Transmission Expansion Advisory Committee Supplemental Projects

PPL Transmission Zone

Scope Change

Need Number: PPL-2025-0010

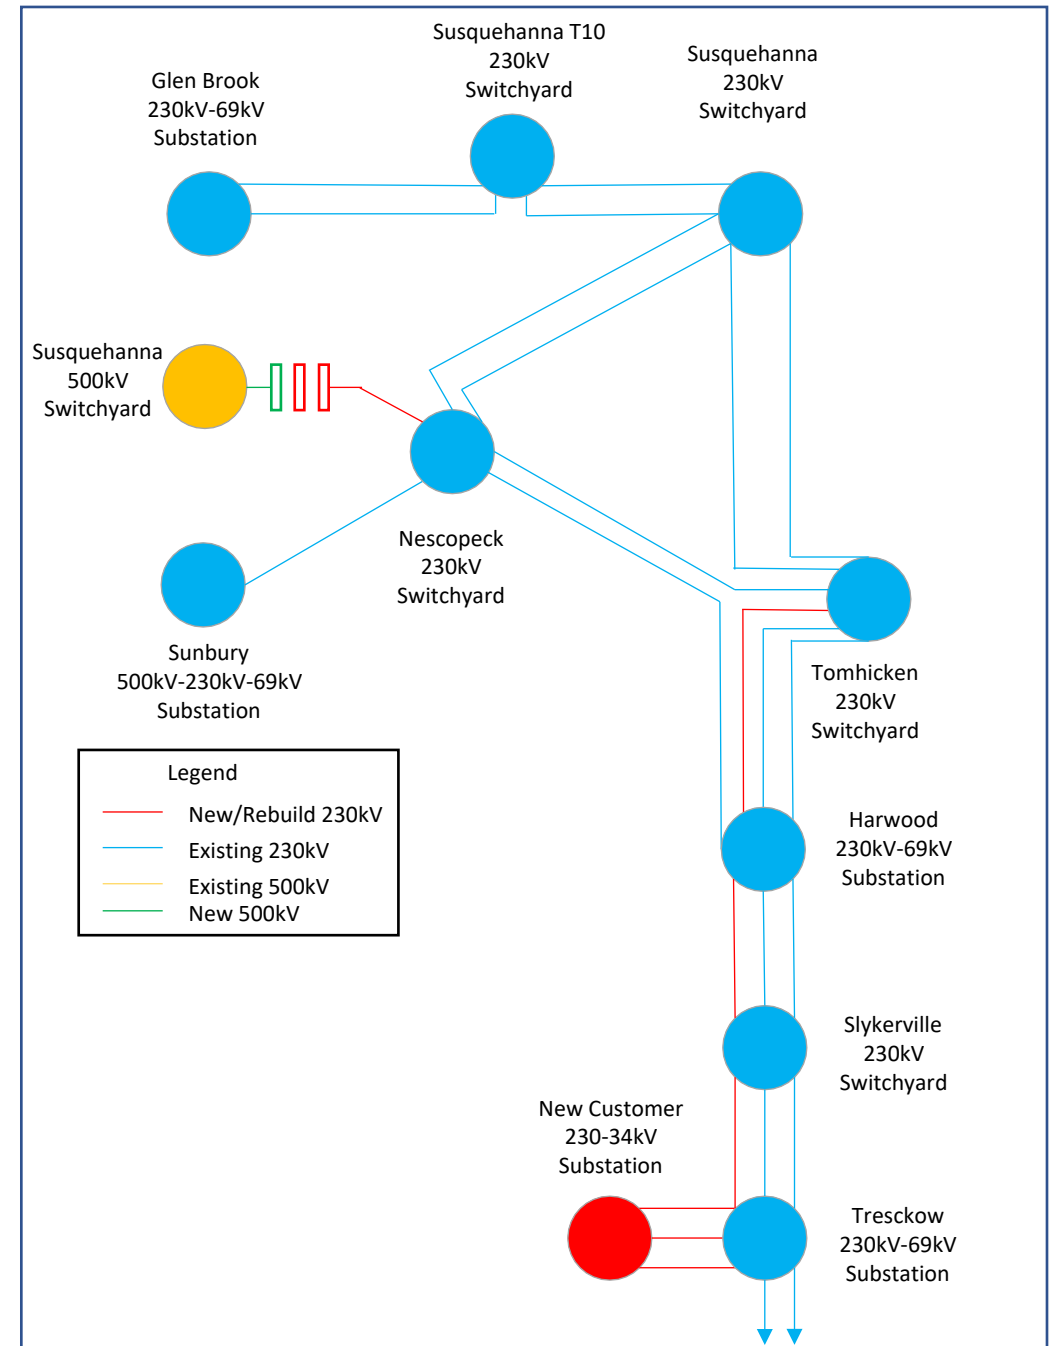
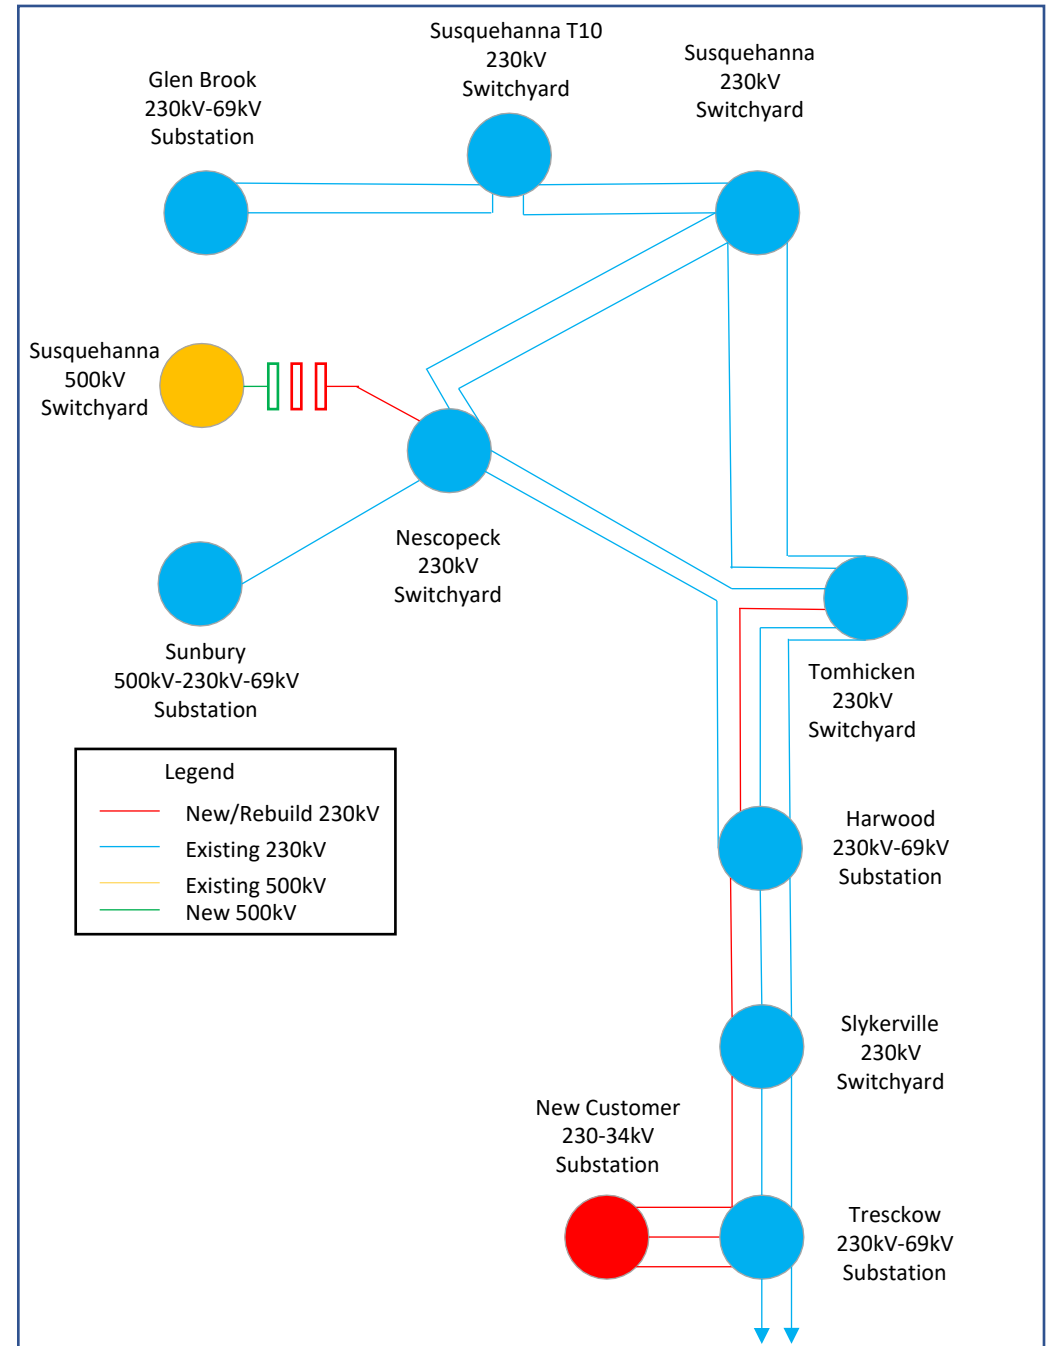
~~**Susquehanna Tomhicken #1 & #2 230kV Reconductor:** Reconductor ~10 miles the Susquehanna Tomhicken #1 & #2 230kV lines from Susquehanna 230kV switchyard to the Tomhicken 230kV switchyard. Estimated Cost: \$12 M~~

Scope now under Baseline project B4029.5

Glen Brook – Susquehanna T10 #1 & #2 230kV Reconductor: Reconductor the limiting section ~0.6 mile section of the Glen Brook – Susquehanna T10 #1 & #2 230kV lines. Estimated Cost: \$1 M

Scope now under Baseline project B4029.13

Estimated Project Cost: ~~\$95M~~ **\$88.5M**
